**Water Resources Integration Program Pipeline, Segment 1A**

**Solicitation Number: B-14-047-DD**

**Job No.: 14-8603**

**ADDENDUM No. 2**

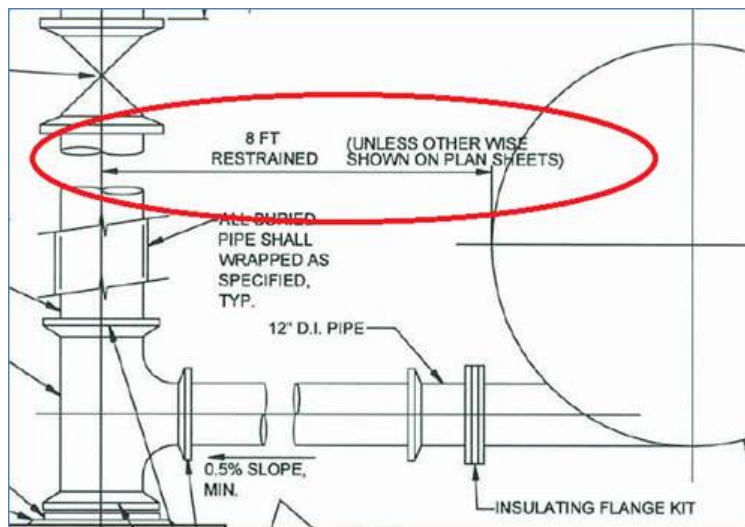
3. Sheet DT02. Add dimensions to the section view in accordance with the following drawing excerpt:

Sheet PP01

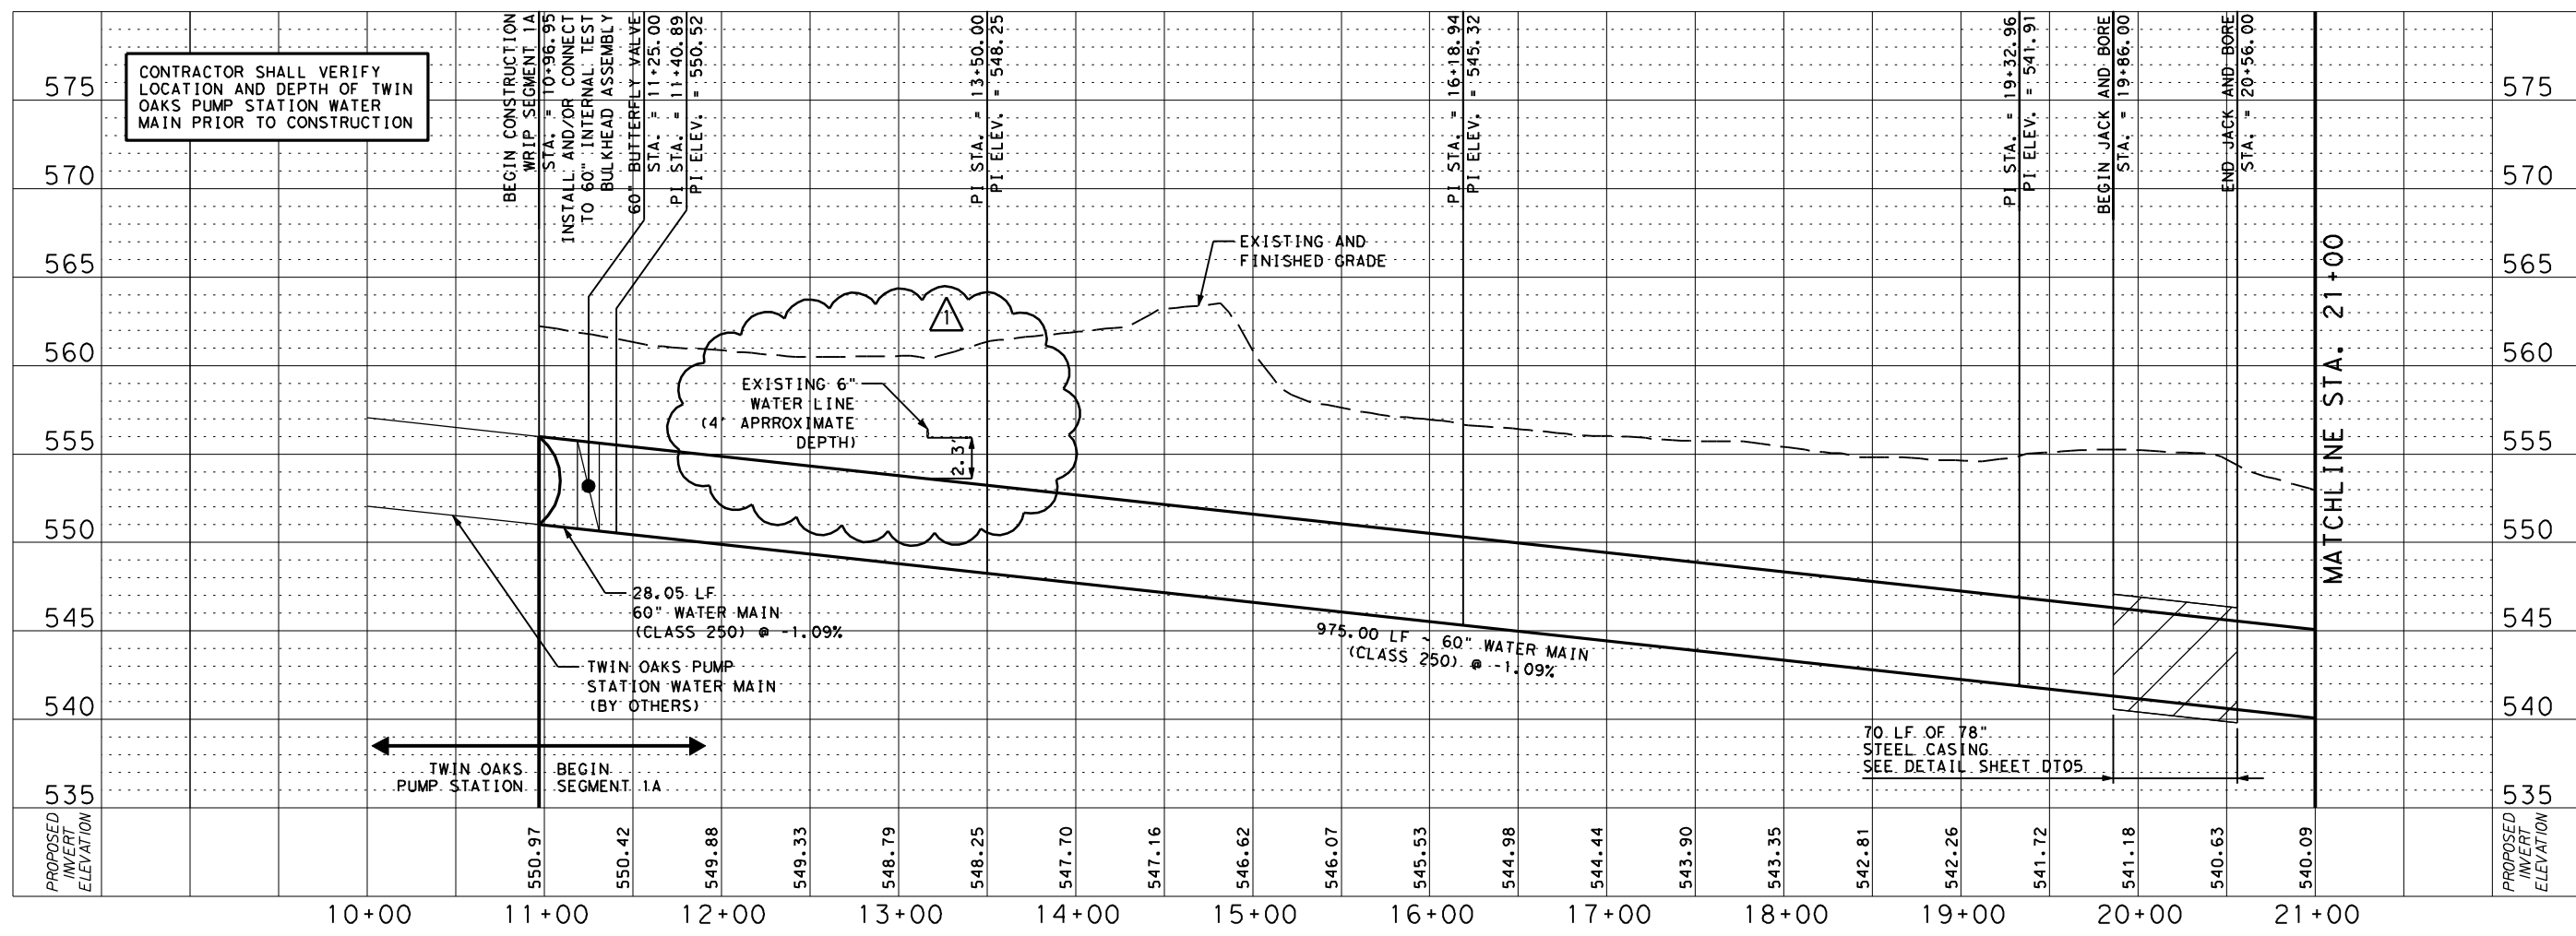
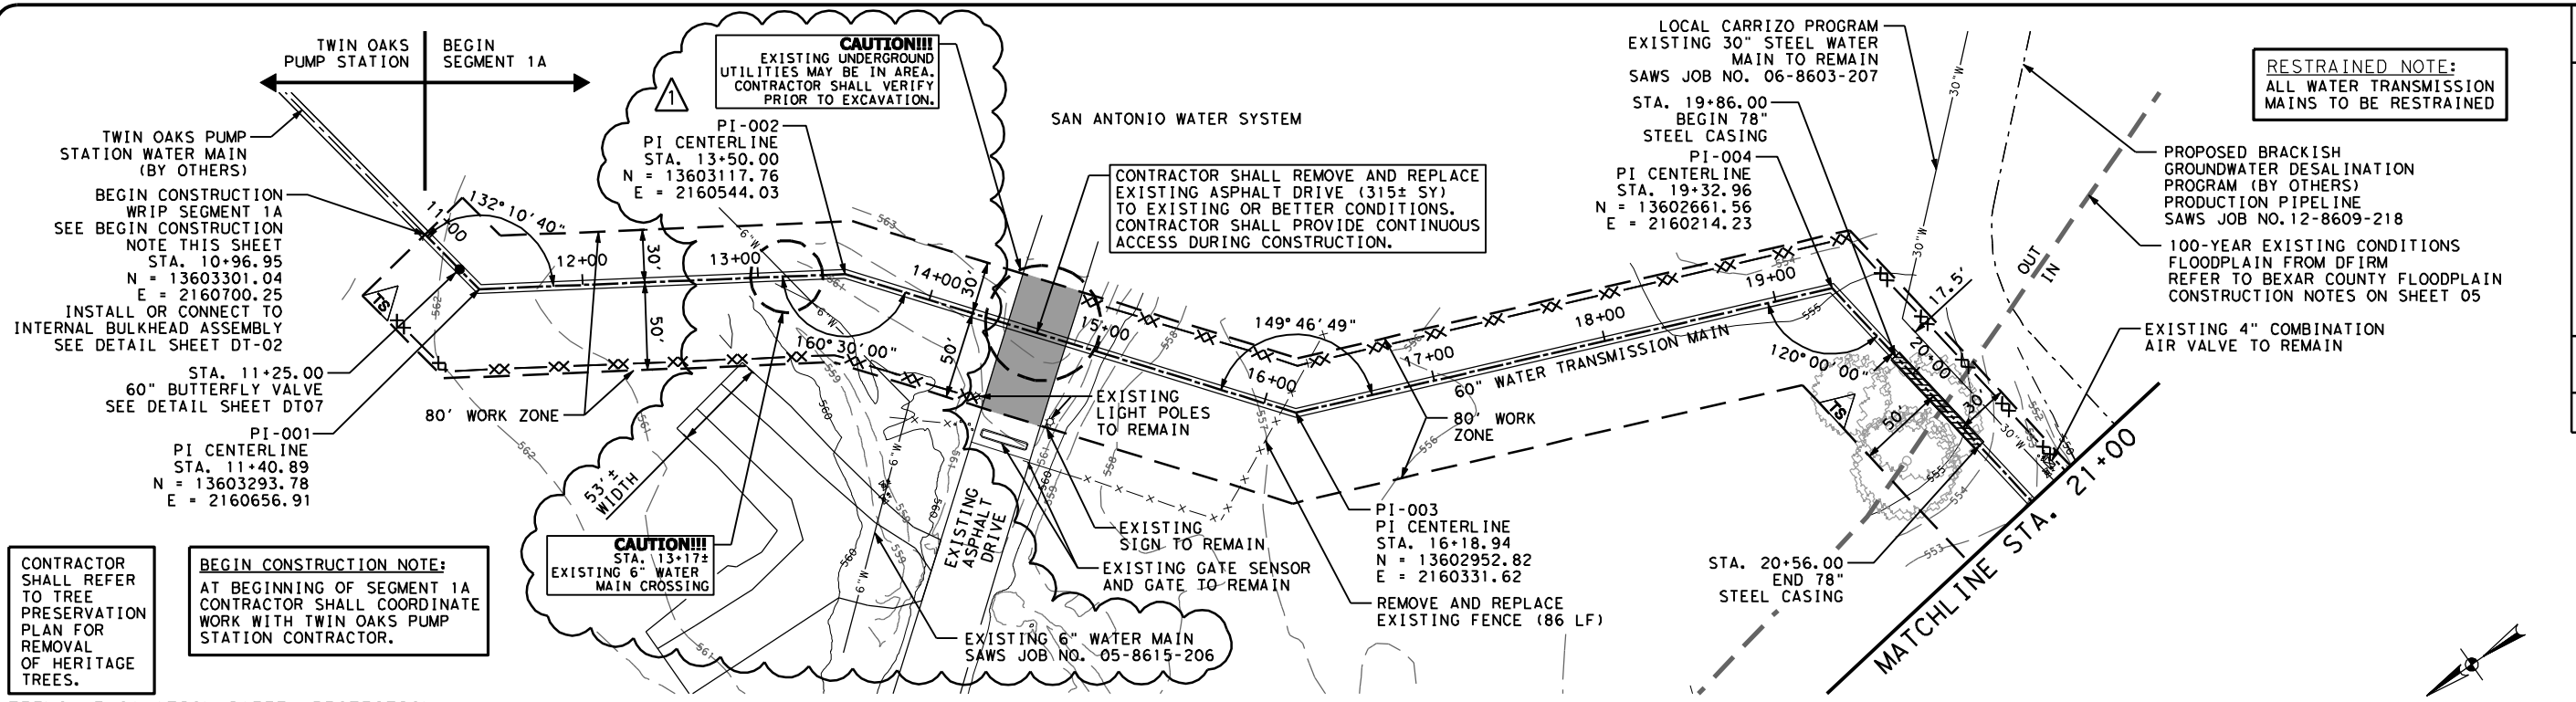
1. Sheet PP01. See attached revised drawing.
2. Sheet DT02. Remove and replace PIPELINE CLOSURE TESTING AND CHLORINATION REQUIREMENT NOTES 7-10 with these revised notes:
